ABINGTON TOWNSHIP

PLANNING COMMISSION MEETING

- a. Consider approving the major subdivision for LD-22-01 DJS Associates located at 1603 & 1617 Old York Road.

RE: LD-22-01-1603 & 1617 Old York Road
PARID: 30-00-49932-00-6 / TMID: 30260 027 (1603 Old York Road)
PARID: 30-00-49944-00-3 / TMID: 30260 025 (1617 Old York Road)
Preliminary Major Subdivision and Land Development Plans Review (1st Submission)

SHEET TITLE:
EXTERIOR ELEVATIONS

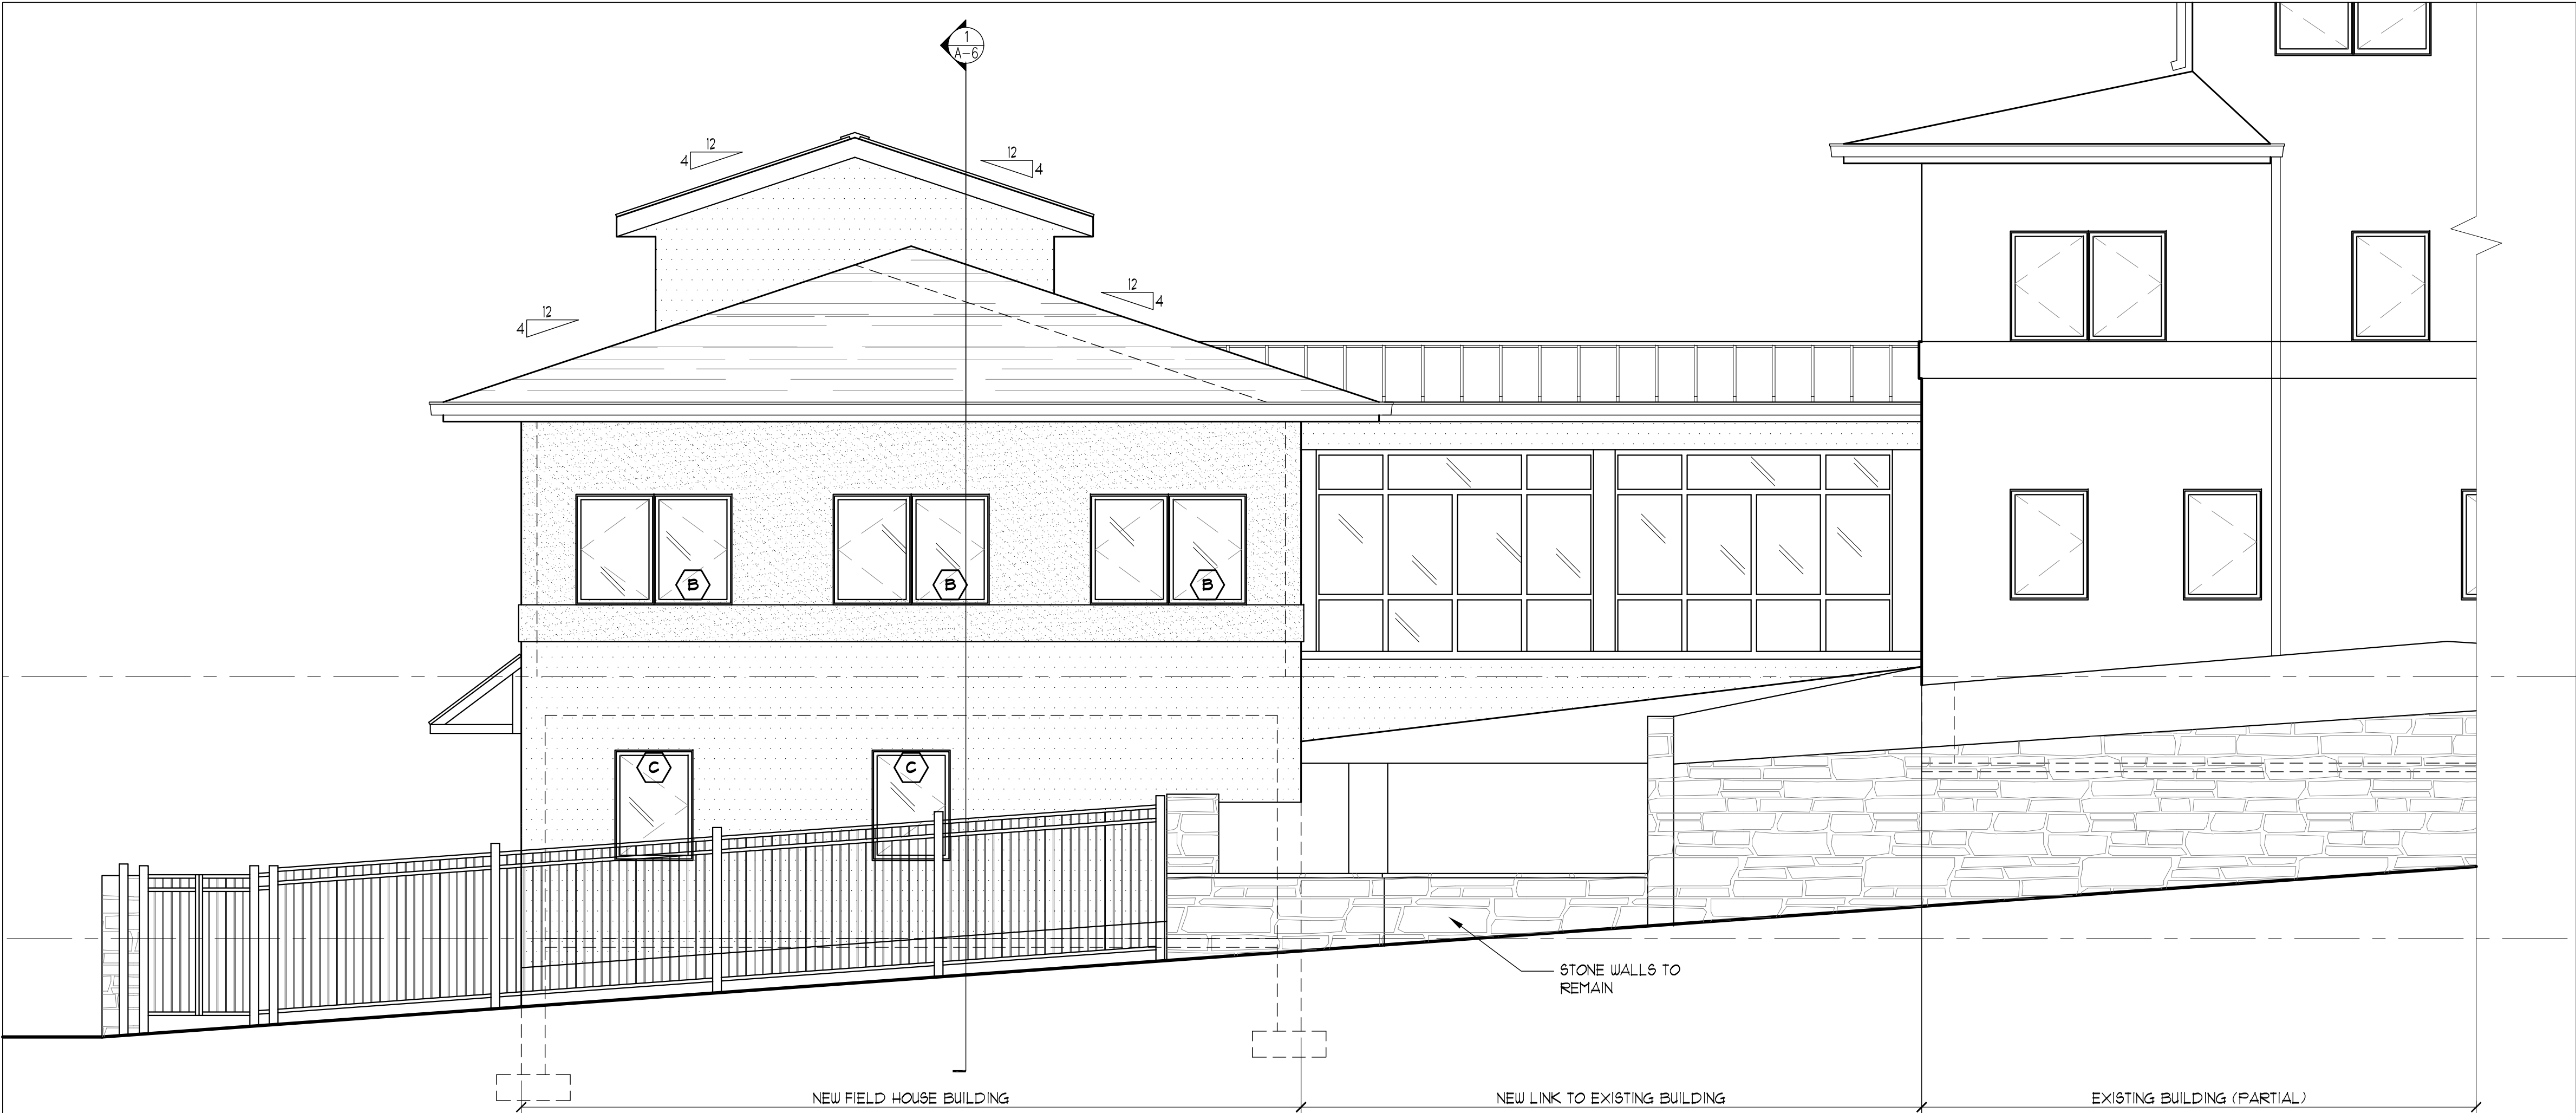
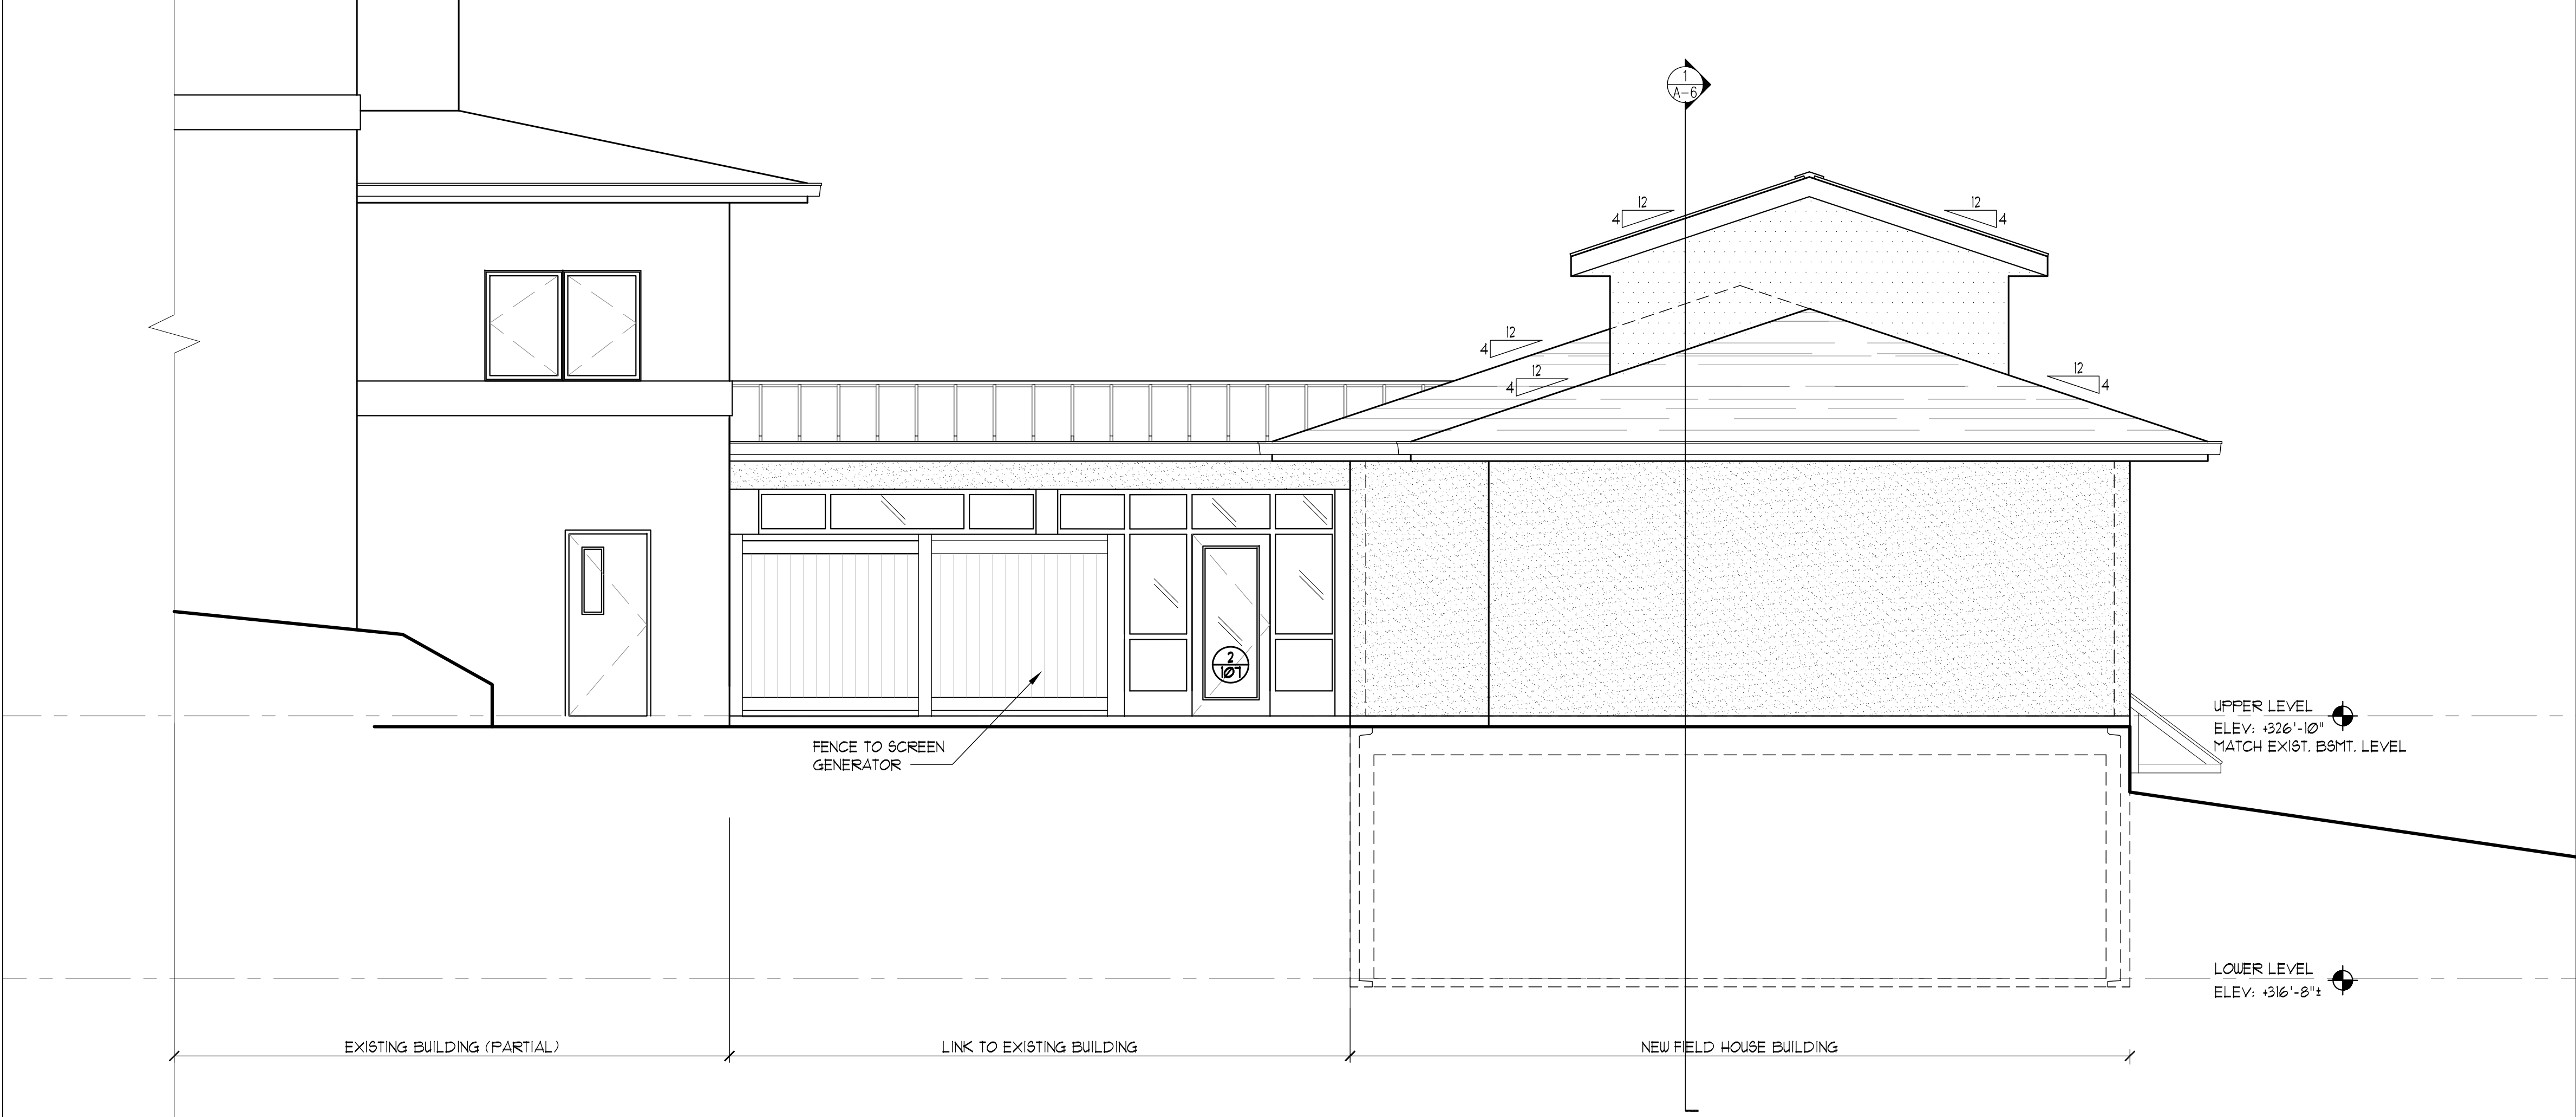
- A. Dumpster – On the Exterior Elevations sheet A-5, a fence is depicted, with a label “fence to screen generator.” Will this fence also screen the dumpster? If not, what kind of screen will the dumpster have? A medium-intensity screen that completely encloses the dumpster is required [Zoning Figure 24.7, p.267], such as an opaque fence or wall (no chain link) with shrubs.
